SUBJECT: ISSUANCE OF AMENDMENT - MILLSTONE NUCLEAR POWER STATION,  
 UNIT NO. 3 (TAC NO. MA1421)

The amendment replaces the pressurizer maximum water inventory requirement with a pressurizer maximum indicated level requirement. The amendment also makes editorial changes and modifies the associated Bases section.

AMENDMENT TO FACILITY OPERATING LICENSE

Amendment No. 160  
License No. NPF-49

FIGURE 3.4-5

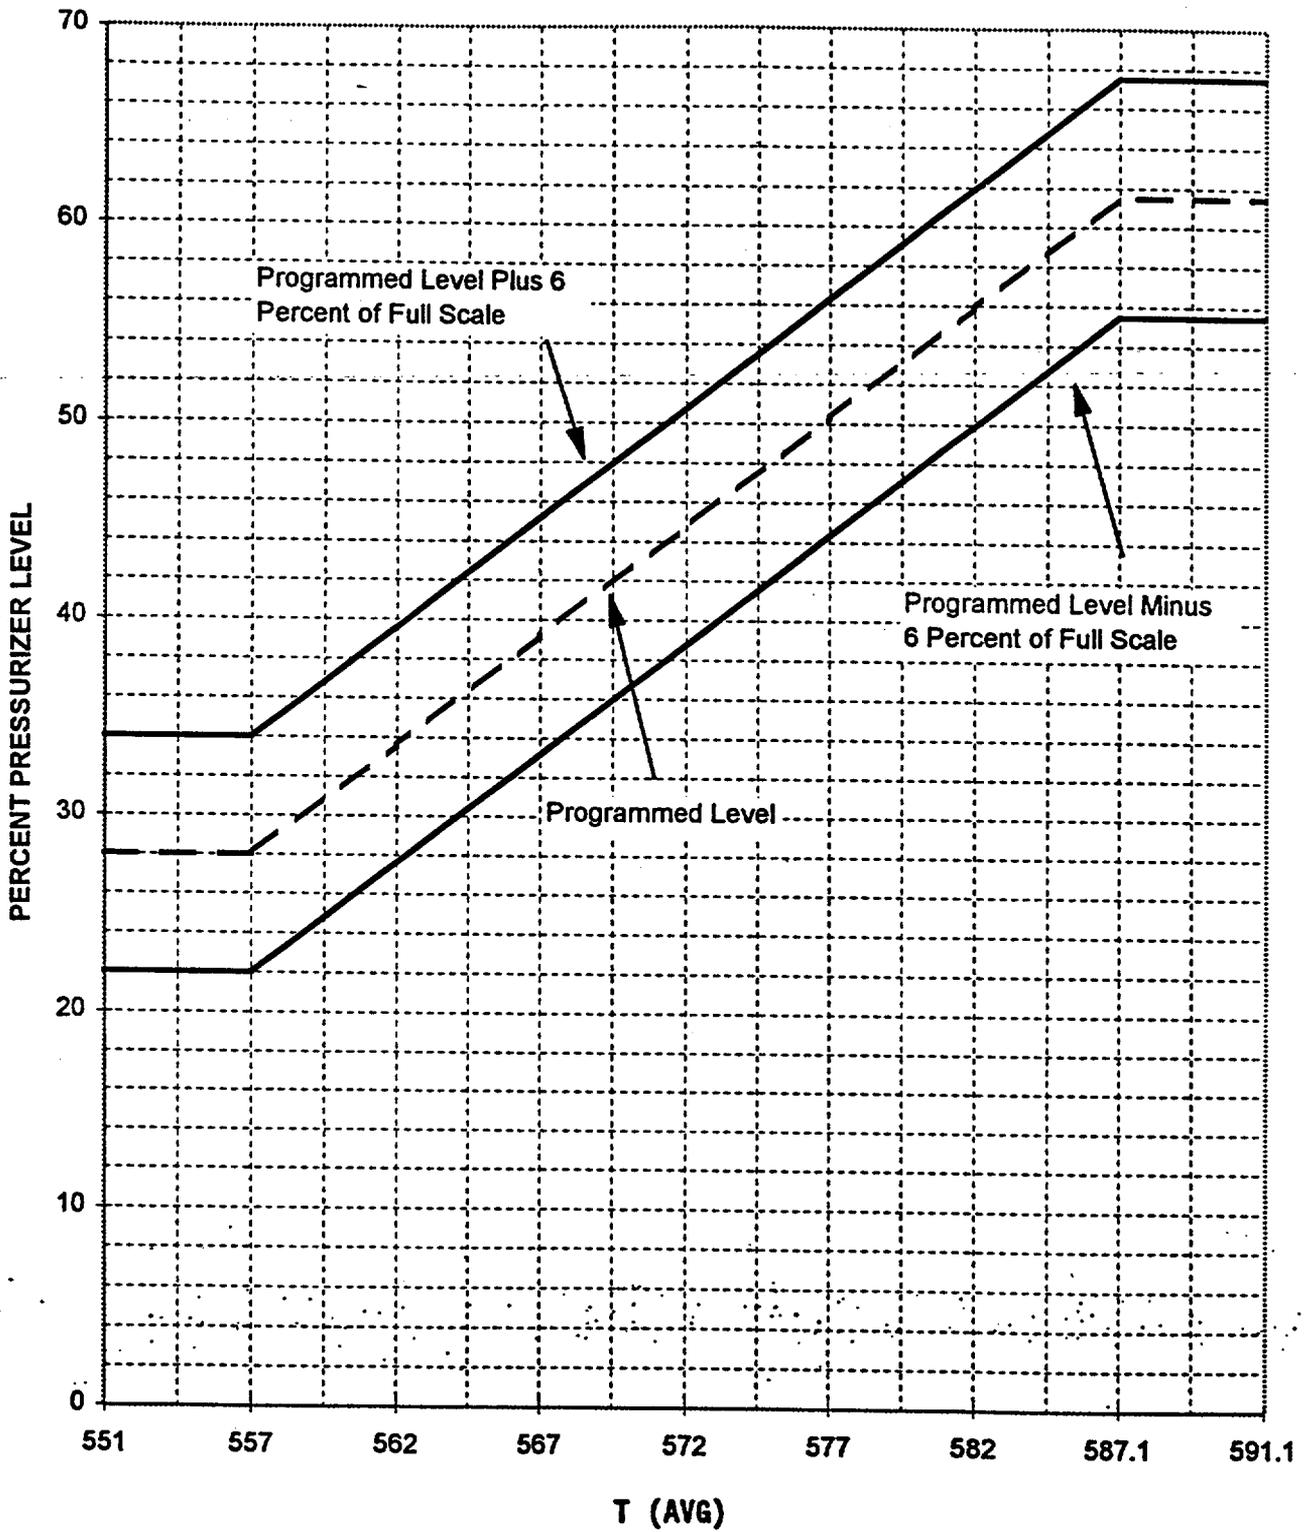
- 3.4.3.1 The pressurizer shall be OPERABLE with:
- at least two groups of pressurizer heaters supplied by emergency power, each having a capacity of at least 175 kW; and
  - water level maintained at programmed level +/-6% of full scale (Figure 3.4-5).

- With only one group of pressurizer heaters supplied by emergency power OPERABLE, restore at least two groups to OPERABLE status within 72 hours or be in at least HOT STANDBY within the next 6 hours.
- With pressurizer water level outside the parameters described in Figure 3.4-5, within 2 hours restore programmed level to within +/- 6% of full scale, or be in at least HOT STANDBY within the next 6 hours.
- With the pressurizer otherwise inoperable, be in at least HOT STANDBY with the Reactor Trip System breakers open within 6 hours.

In the April 7, 1998, letter, the licensee proposed to expand the current TS 3.4.3 into two separate TS (TS 3.4.3.1 and TS 3.4.3.2). TS 3.4.3.1 will be applicable to Modes 1 and 2. TS Figure 3.4-5 provides the curves of programmed pressurizer level and the operational limits (programmed level +/- 6 percent) for power operation. Limiting Condition for Operation (LCO) 3.4.3.1 requires that the pressurizer water level be maintained at a programmed level +/-6 percent of full scale. This proposed TS will bound the assumed initial conditions for those transients where pressurizer overflow is a concern (e.g., loss of feedwater, feedwater line break,

and inadvertent actuation of safety injection system at power). The +/- 6 percent of full scale acceptance criterion in the TS covers the instrumentation uncertainties.

The staff has reviewed the licensee's request and finds that proposed TS 3.4.3.1 and TS 3.4.3.2 are conservative and consistent with the safety analyses documented in Chapter 15 of the Millstone Unit 3 FSAR. Therefore, the staff has concluded the changes are acceptable. The staff has also reviewed the editorial changes and finds them acceptable.
